14402 Dorsey Mill Rd N

From: Silvast, Zackary
Sent: Wednesday, June 7, 2023 5:22 PM
To: gilmer@clarksvilleconstruction.net
Cc: drawings@lapodolak.com; Eshenbaugh, Melanie
Subject: regarding 14402 Dorsey Mill Road perc plan revision comments

Re: ***Percolation Test Report***
14402 Dorsey Mill Road
Glenwood, MD 21738

PERCOLATION CERTIFICATION PLAN for LOT #2 'ROBERT H. DILL PROPERTY'
(RECORDED AMONG THE LAND RECORDS OF HOWARD COUNTY, MARYLAND IN PLAT: R.H.M. 6-93)

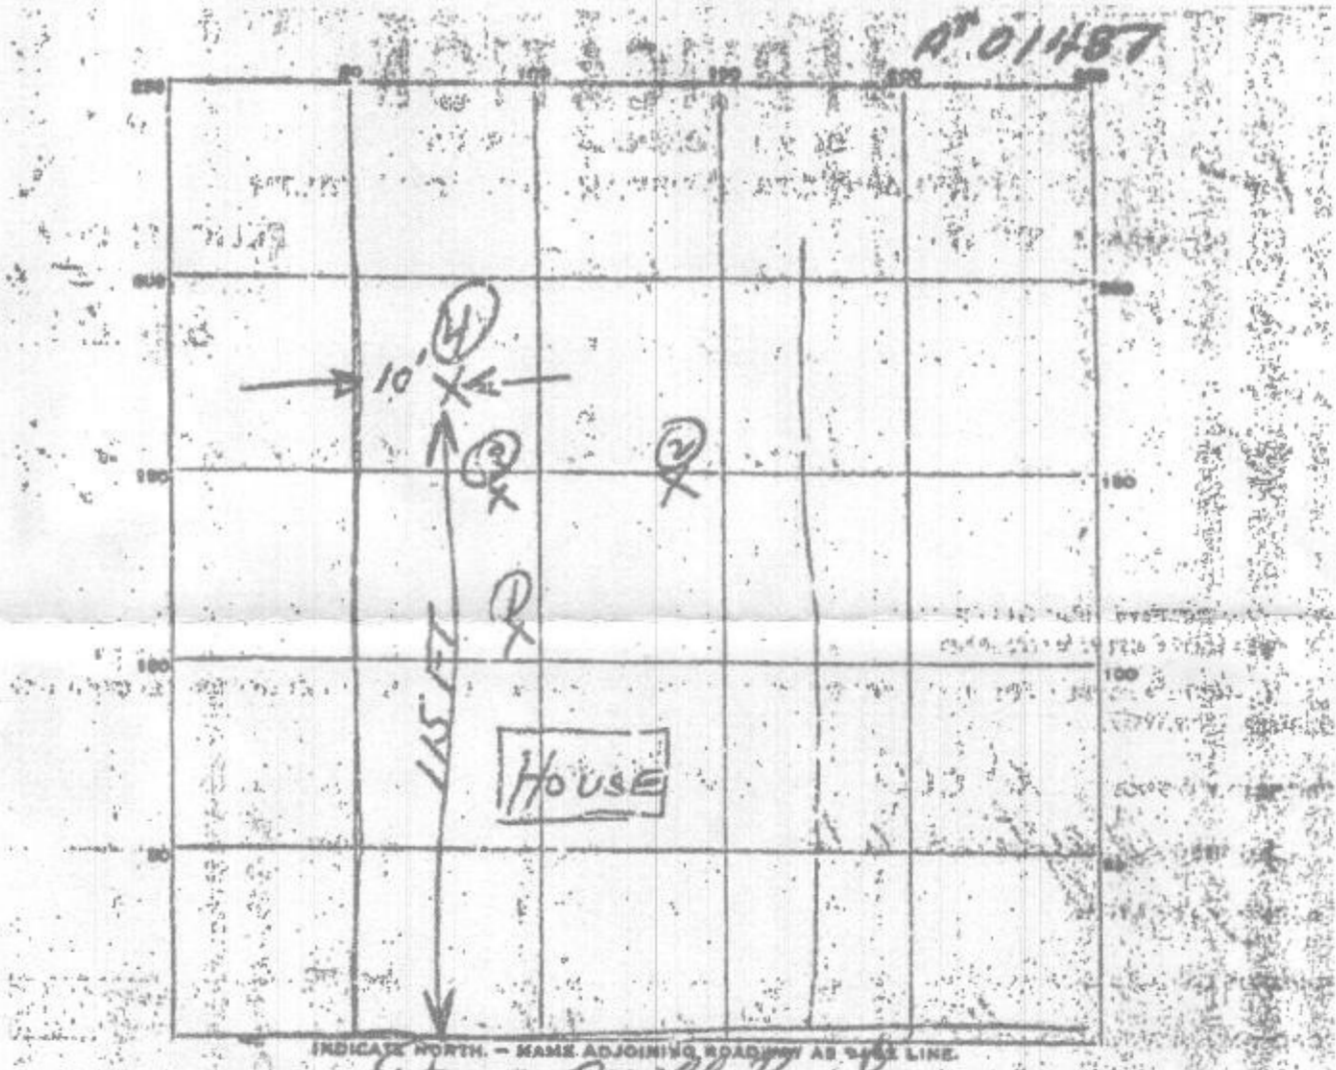
- In comparing the perc locations shown on the PC to the previous percolation record for the property, they appear to be shown incorrectly
- Due to the lack of soil information on the previous perc test record, the trench proposed for replacement #1 would need an additional 1-2 holes to consider this area

- In order to establish a split SDA, an additional 2-3 proposed perc holes would be necessary
- The test hole dug near the existing system would need to be staked in order to utilize this observation for the PC

- Area shown for replacement system #2 would need an additional test hole 40' equidistant from perc holes 8 & 9
- If the existing drywell is to be retained, it would need to be pumped and filled with stone and an inlet depth at 2-3'

- The comment notes for the proposed systems should be removed and these specific details would be included on an OSDS plan
- In reference to the 2nd replacement system, any trench less than 30ft in length would require a BAT & LPD, and the specs would be based on a .8 rate (LR) with 3' of sidewall credit and a max bottom depth at 8 ft.

1. **Need to label the well properly, provide tag number or write "no tag" if applicable.**
 - a. **Need to clarify what type of well it is. (i.e. drilled, pit, driven, dug, jet)**

2. **Need to propose two alternative well sites or a 1500 sq. foot well box.**
 - a. **Need to show all 100' well arcs.**
3. **A drywell is not abandoned if it is acting as a distribution box. May need to be upgraded.**

4. **Is the tank concrete or metal?**
5. **Are the property owners trying to keep their existing septic system or are they willing to abandon it. Need to clarify and label accordingly.**

6. **Is the shed permanent or non-permanent? Label correctly.**
7. **Need 5 perc holes, four to set the boundaries and one middle hole.**
 - a. **They should be spaced roughly 60' apart.**

8. **Need to show the septic and structures on neighboring lots 1 & 12.**
9. **Need to label proposed and existing SDAs.**
 - a. **Should be different in legend.**

- b. **Need to list exact square footage on plot plan.**
10. **Need to extend the contours outward beyond the property boundaries.**
11. **Need to show 9757 & 9753 Gingerwood Drive well and septic on the back of those properties (whichever is applicable)**

12. **Note 6 should say "sewage disposal area."**
 - a. **Fix in legend also.**
13. **Note 8 needs to be revised. Also why?**
 - a. **Purpose statement should be in its own box below the general notes labeled properly.**

14. **Need to put distance between shed and SDA.**
15. **Need to add a note stating that an approved OSDS plan will be required prior to building permit issuance.**

Comment #1: General Note #8 has been removed from the plan.

Comment #2: The portion of the note regarding the existing system, beginning with "Howard County Health Dept evaluated this system in the field....Health Dept. files" has been removed.

Comment #3: The 2,200 square foot septic area for the second replacement system has been revised so that it will not extend past the 552 foot contour.

Comment #4: To eliminate the need for a LPD disposal system, this 2,200 square foot sewage disposal area has been extended 5 foot toward the neighboring property. Based on your correspondence, the Health Department has decided to grant a general waiver to reduce the minimum setback from the property boundary line to 5 feet, in lieu of the 10 foot required in the Executive Regulations. Also based on your correspondence this variance has been extended for both septic disposal areas. A note has been added to the plan depicting this waiver.

Comment #5: The elevation of each percolation test location is now provided on the plan.

Comment #1: The Sewage Disposal Area has been reconfigured so that it does not extend beyond Perc Test #15.

Comment #2: General Note #9 has been removed from the Plan since an On-Site Sewage Disposal Plan will not be required for the proposed deck and patio building permit.

Comment #3: The legend on the Plan has been updated to indicate a symbol for the failed percolation tests.

Comment #4: The original percolation tests, numbered 1 thru 4, have been updated in the Legend to reference the date when these tests were conducted.

Comment #5: The MDE statement regarding the fact that the lot was created prior to 1972 has been moved from the legend to General Note #9.

Comment #6: The wells and septic systems have been shown for 14408 Dorsey Mill Road, and labeled appropriately.

Comment #7: The sewage disposal system for 14376 Dorsey Mill Road has been accurately depicted on the plan, and the two replacement wells have been located so that they will not interfere with this septic system.

Comment #8: The sewage disposal systems for both 3920 and 3938 Sharp Road are depicted on the Plan.

Comment #9: The proposed screened porch and deck have been shaded to indicate that this is proposed construction.

Comment #10: The circle around the failed percolations tests has been removed.

Comment #11: The Purpose Note on the Plan has been updated to include the fact that we are seeking a building permit for a proposed deck and patio.

Comment #12: The Sewage Disposal Area has been cross hatched, and rather than depicting a well box, we are showing two replacement wells.

Comment #13: We were able to depict the wells and septic systems of the adjoining properties without having to change the drawing scale.
